USB Type-C ENGINEERING CHANGE NOTICE

Title: Handling EPR exits

Applied to: USB Type-C Specification Release 2.3, Oct 2023

Figure 2 Exiting from Attached.SRC with slow discharging V_{BULK} .

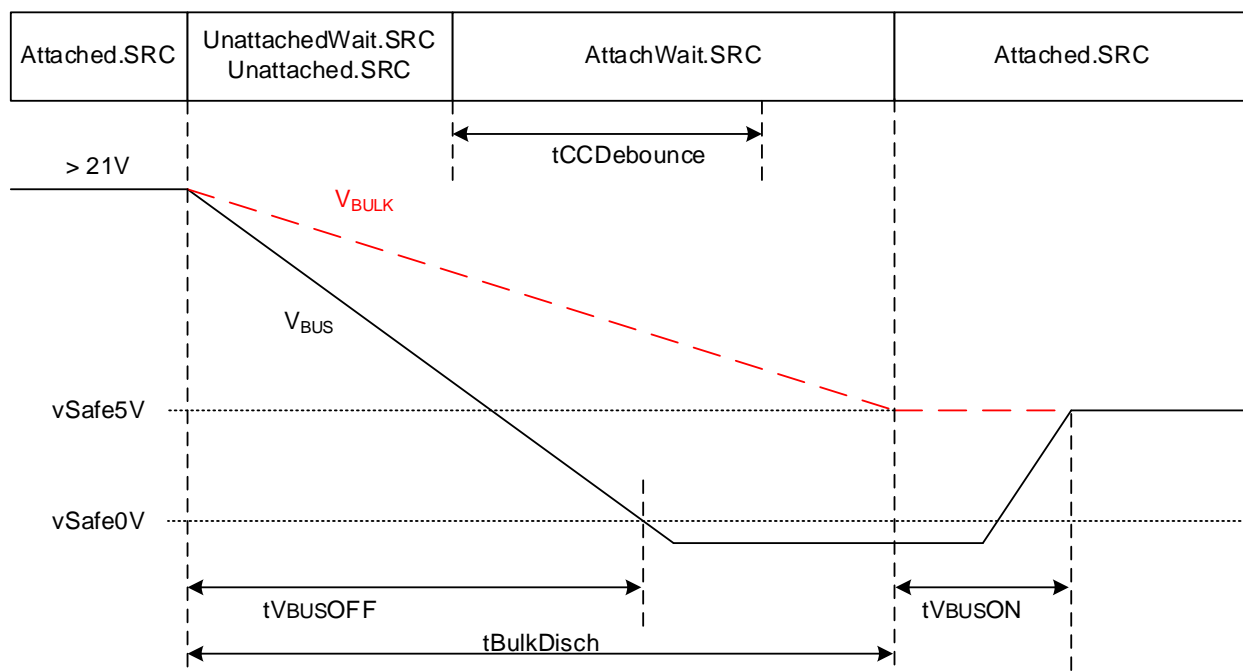
Figure 2 shows a scenario following a contract with V_{BUS} above 21V. In this example system, the $t_{CCDebounce}$ timer completes before the source is ready to supply V_{BUS} at v_{Safe5V} since $V_{BULK} > v_{Safe5V}$. Note that many implementations will discharge V_{BUS} below v_{Safe0V} much faster than $t_{VbusOFF}$ (max).

Figure 3 Exiting from Attached.SRC with fast discharging V_{BULK} .

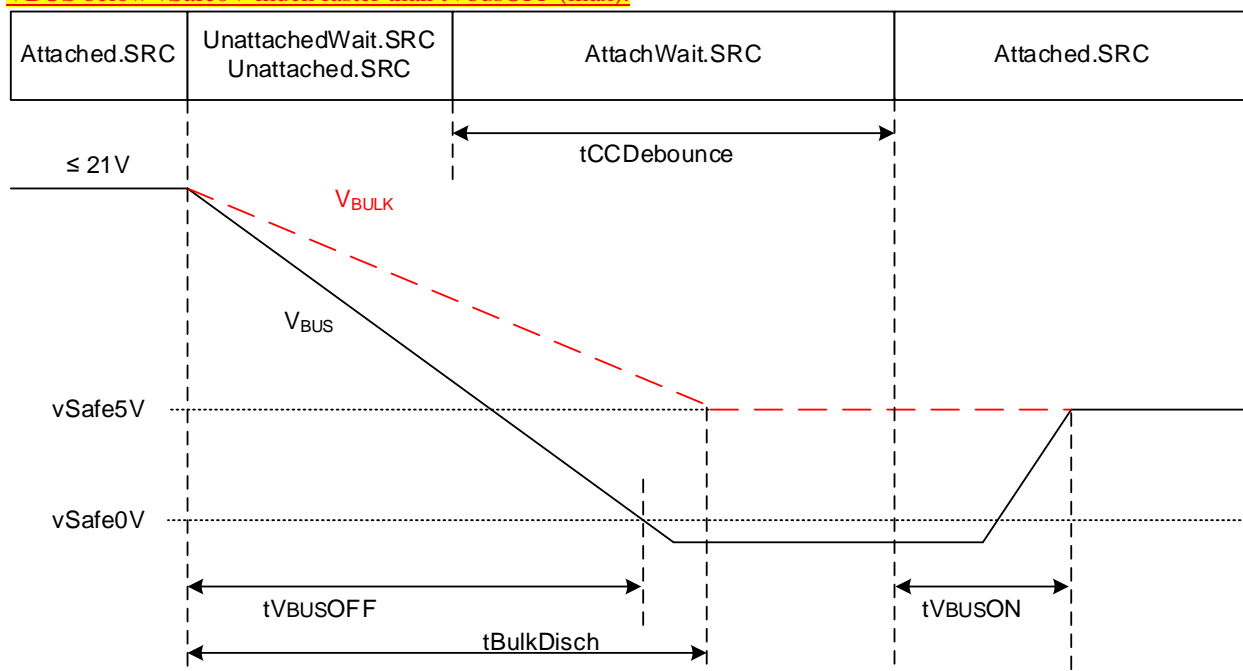
Figure 3 shows a scenario following a contract with V_{BUS} at 21V or below. In this example system, the V_{BULK} is discharged to v_{Safe5V} before the $t_{CCDebounce}$ timer completes. Note that many implementations will discharge V_{BUS} below v_{Safe0V} much faster than $t_{VbusOFF}$ (max).
